UNITED STATES
DEPARTMENT OF THE INTERIOR
BUREAU OF LAND MANAGEMENT
NM OIL CONSERVATION
ARTESIA DISTRICT
JUN 29 2015FORM APPROVED
OMB NO. 1004-0135
Expires: July 31, 2010**SUNDRY NOTICES AND REPORTS ON WELLS**
*Do not use this form for proposals to drill or to re-enter an abandoned well. Use form 3160-3 (APD) for such proposals.***SUBMIT IN TRIPLICATE - Other instructions on reverse side.**

Yates Petroleum Corporation plans to plug and abandon this well as follows:

Magellan Federal Unit #3
Sec 4-T25S-R27E
Eddy County, New Mexico
Page 2

WELL NAME: Magellan Federal Unit #3

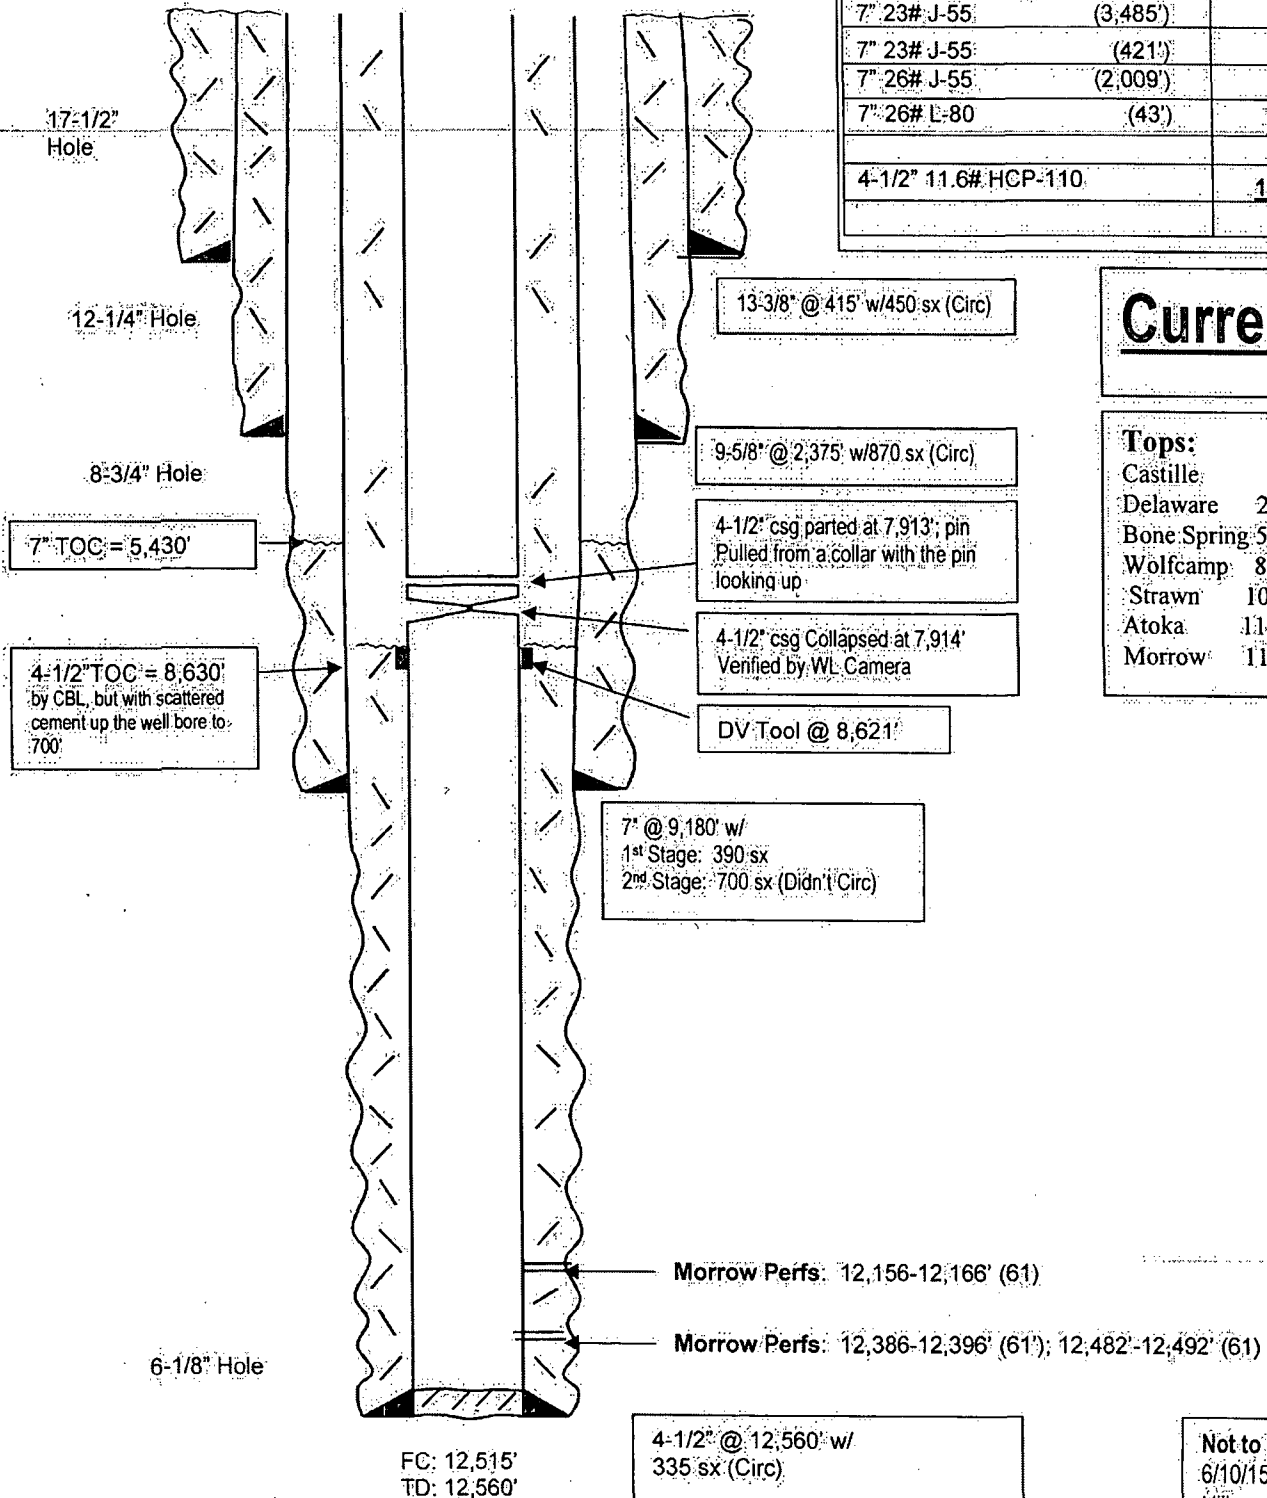
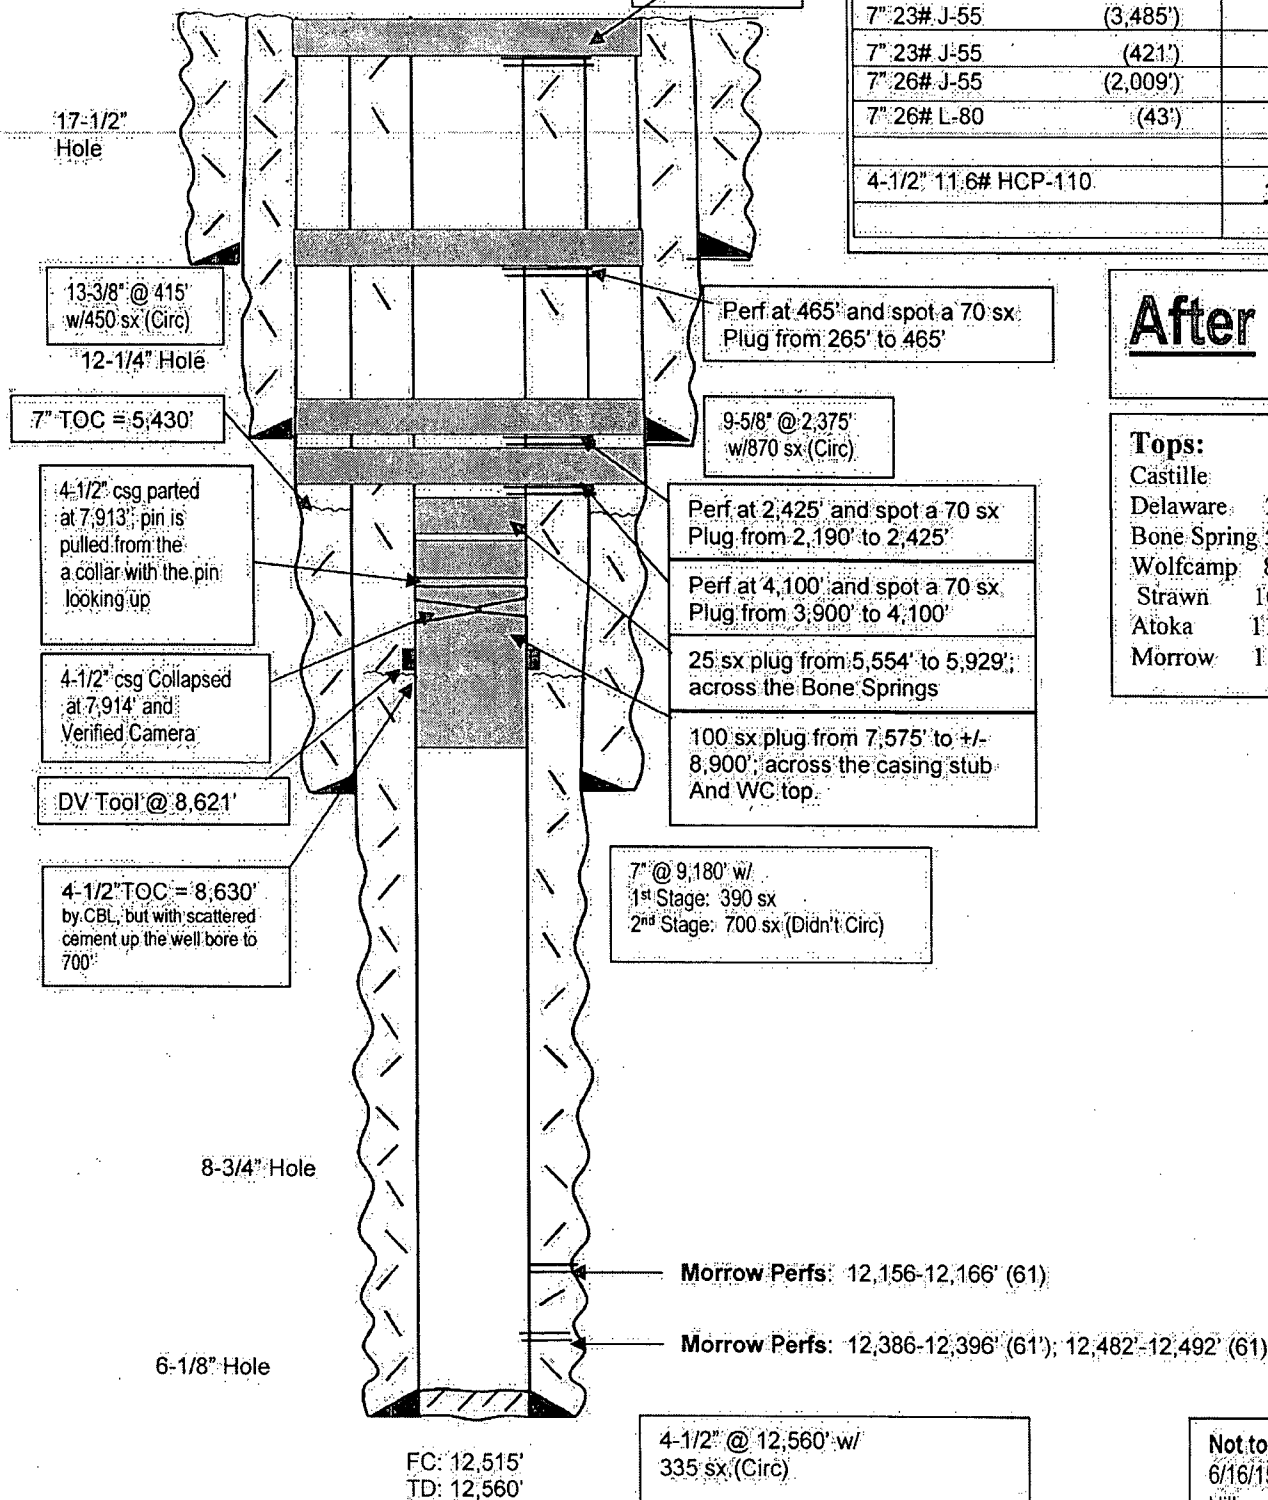
Verify cut to surface all annulus @ cutoff.
